**MODEL 5345A 500 MHz UNIVERSAL PLUG-IN COUNTER****All Options and Serial Number Prefixes****5345A INPUT SENSITIVITY FREQUENCY DEGRADATION**

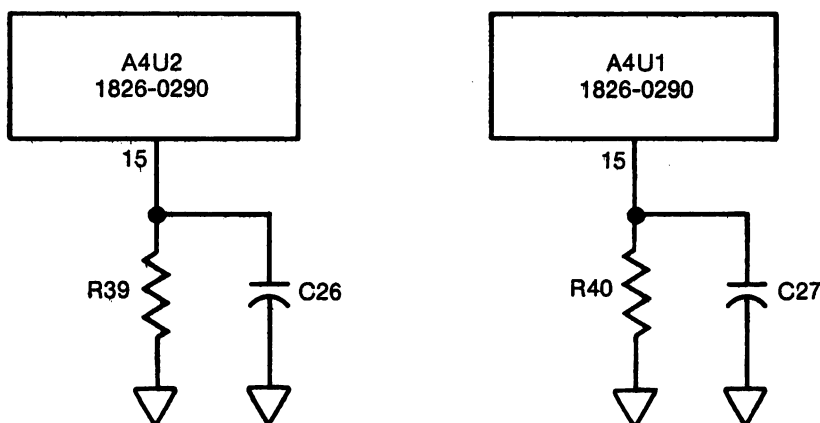
If the 5345A does not have enough input amplifier sensitivity at 500 MHz, a solution to increase the bandwidth of sensitivity range is to solder a 22 pF capacitor (P/N 0160-3875) between pin numbers 15 and 16 of A4U1 and A4U2. See schematic below. This change is documented in the latest manual change sheet.
